CNL-19-007

Browns Ferry Nuclear Plant, Units 1, 2, and 3
Renewed Facility Operating License Nos. DPR-33, DPR-52, and DPR-68
NRC Docket Nos. 50-259, 50-260, and 50-296

Subject: Proposed Technical Specifications (TS) Change TS-510 - Request for License Amendments - Maximum Extended Load Line Limit Analysis Plus - Supplement 5, Response to Requests for Additional Information

Figure SRXB RAI-5c-1

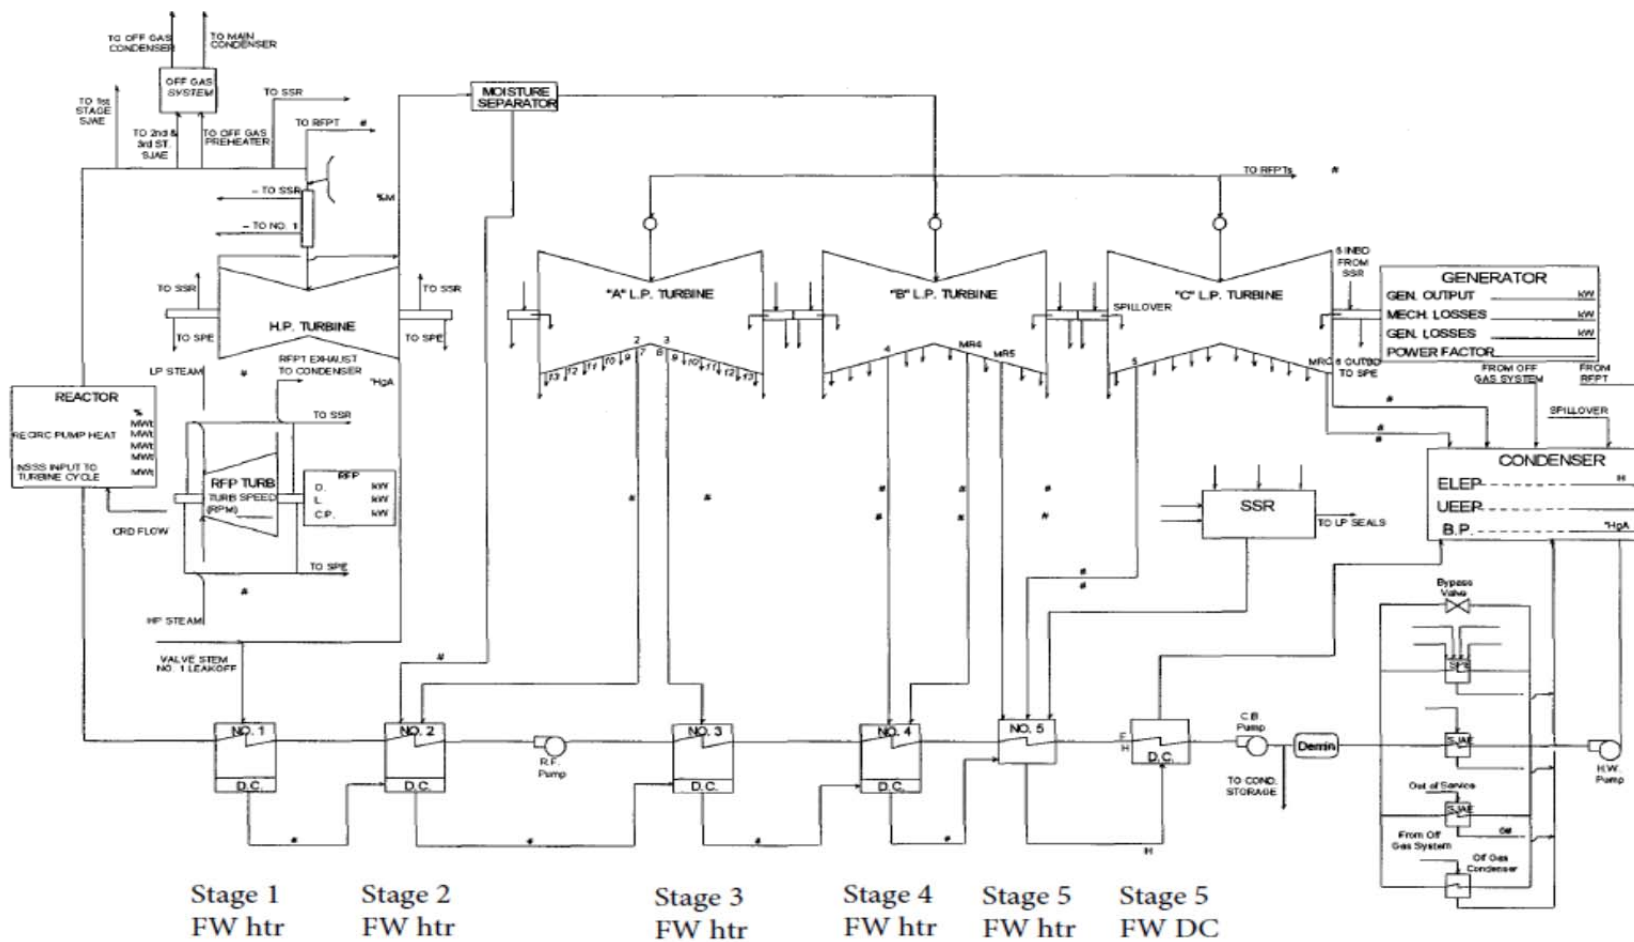
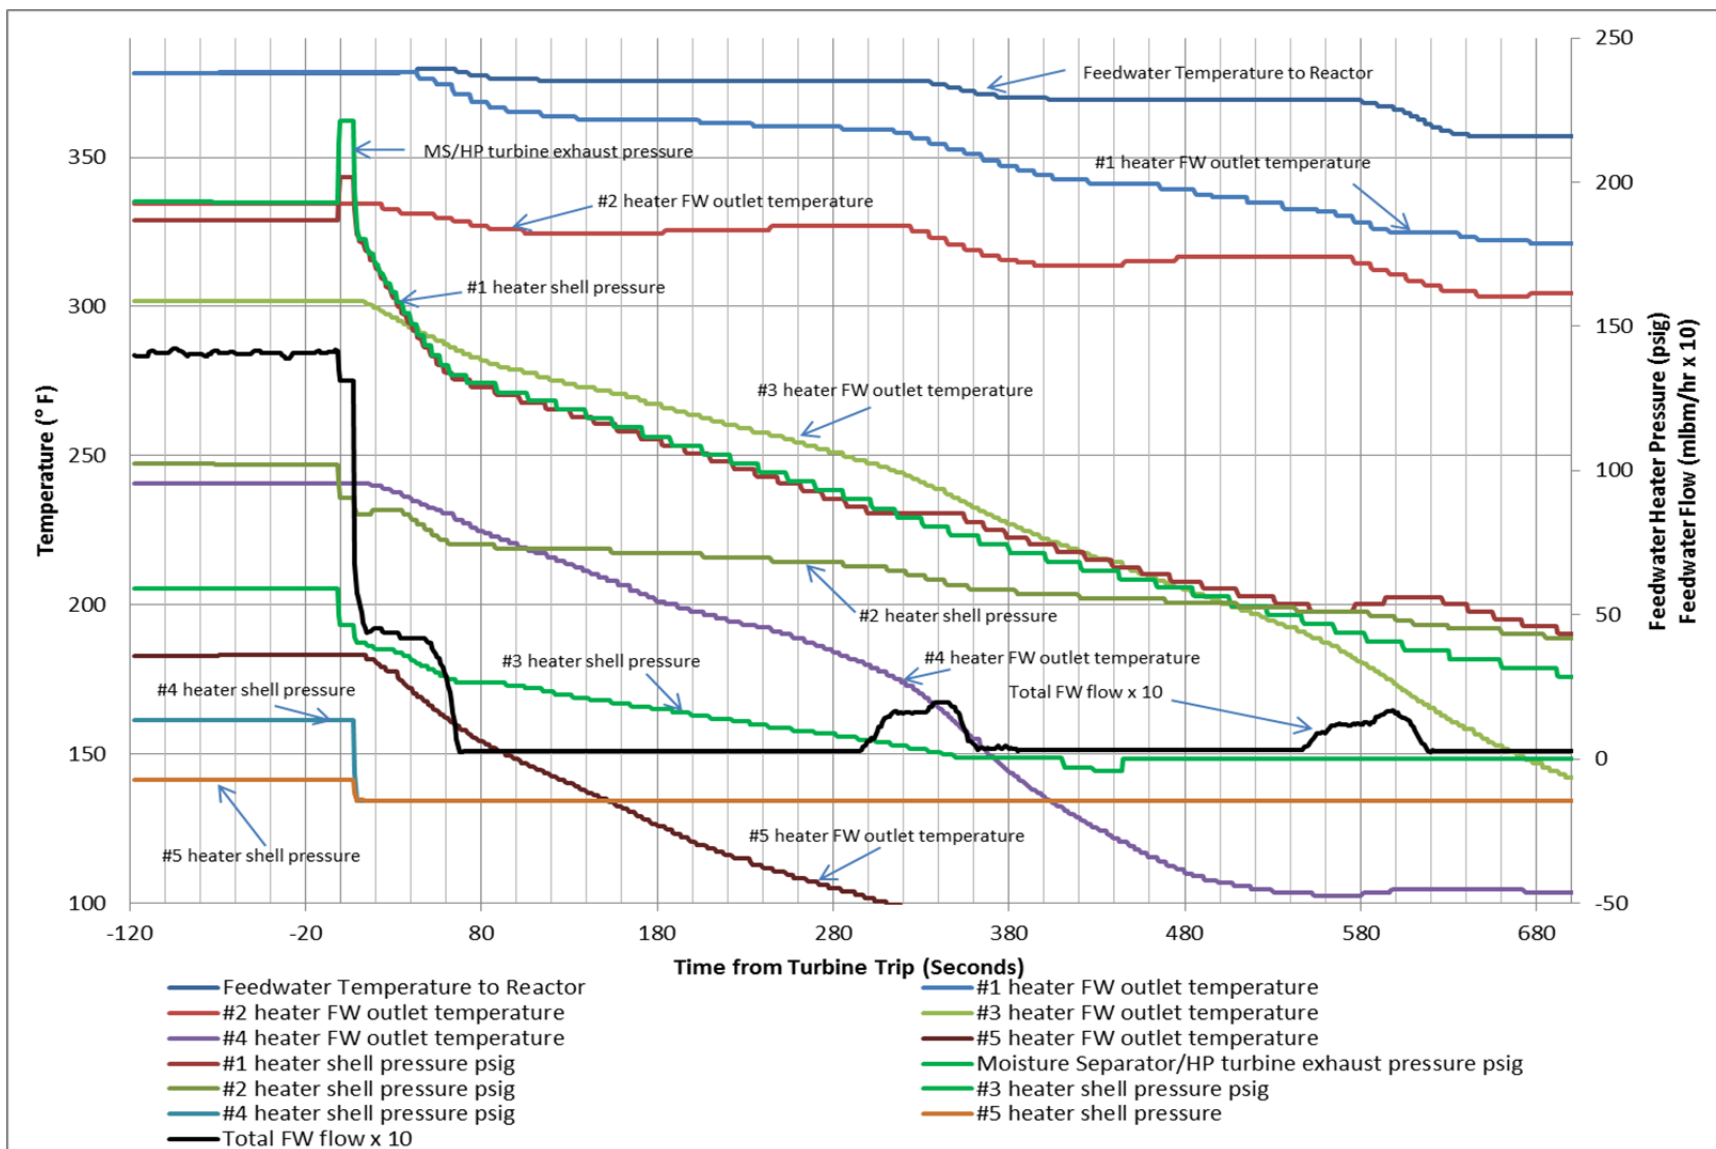
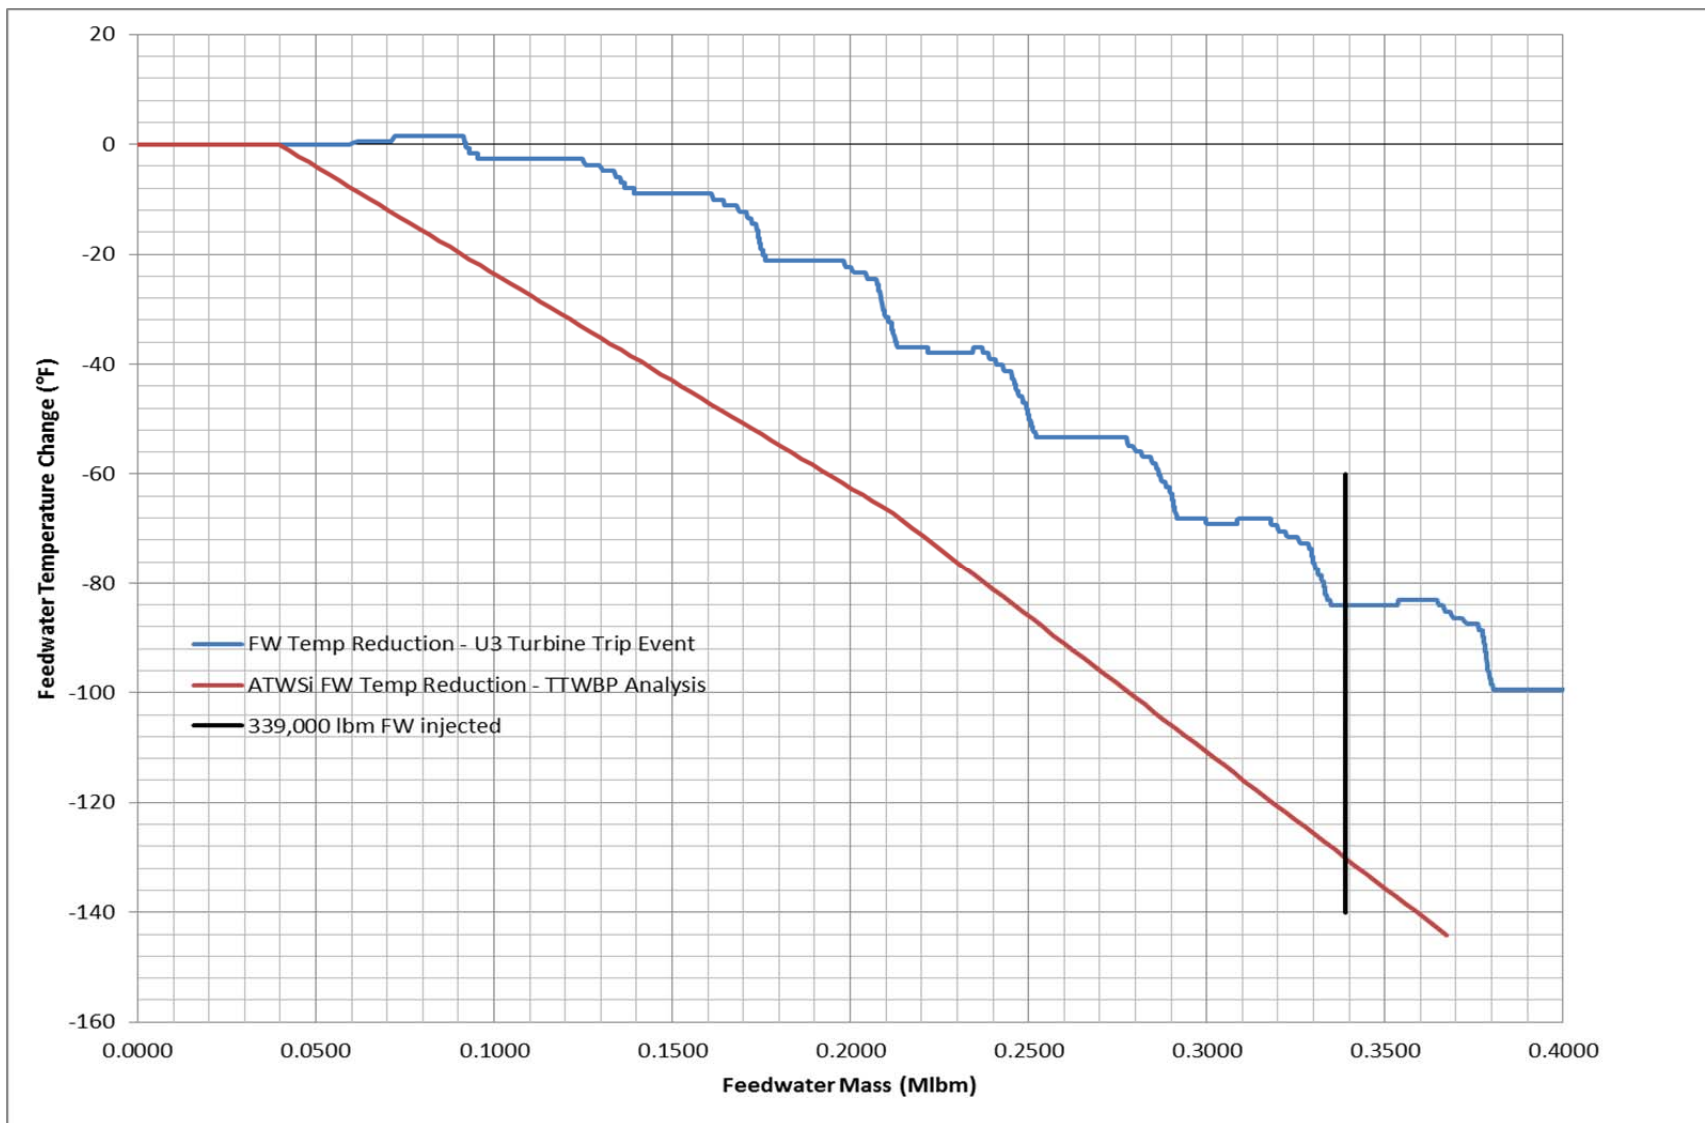
- a. Provide the basis for the 39,800 lbm used in the calculation which determined the 14 seconds delay time.*
- b. Justify that the 14 seconds delay time is bounding relative to the turbine trip event data for BFN, Unit 3.*
- c. Explain why the feedwater temperature reduction rate changes during the turbine trip event at BFN, Unit 3 (Step 1, Step 2, and Step 3) and please discuss why this is bounding for ATWS-I.*
- d. Please compare the TRACG feedwater temperature input to ATWS simulator data to demonstrate that the feedwater temperature used in the analysis is conservative.*
- e. Please provide justification that this basis is also applicable to the feedwater temperature reduction for the 2RPT event.*

Based on rated FW flow (i.e., 16.4 Mlbm/hr) and assuming 62% power (i.e., reactor power at reactor natural circulation), the mass of FW required during the first 120 seconds of a high-power ATWS event is just under 339,000 lbm. Figure SRXB RAI-5c-3 shows the change in FW temperature on a per unit mass basis for the 2004 BFN Unit 3 turbine trip event compared to the change in FW temperature on a per unit mass basis for the assumed FW temperature reduction used in the BFN TTWBP ATWS-I event. Observation of the data plotted in Figure SRXB RAI-5c-3 provides additional confidence that the assumed FW temperature reduction rate used in the BFN TTWBP ATWS-I analysis bounds the expected BFN plant response. As noted in part b of this RAI response, the power reduction and corresponding FW flow reduction to natural circulation conditions is not instantaneous. This would result in a slightly higher mass of FW injected during the first 120 seconds of a high-power ATWS event. However, this larger mass of FW injection does not alter the conclusion drawn from Figure SRXB RAI-5c-3 that the assumed FW temperature reduction rate used in the BFN TTWBP ATWS-I analysis bounds the expected BFN plant response.
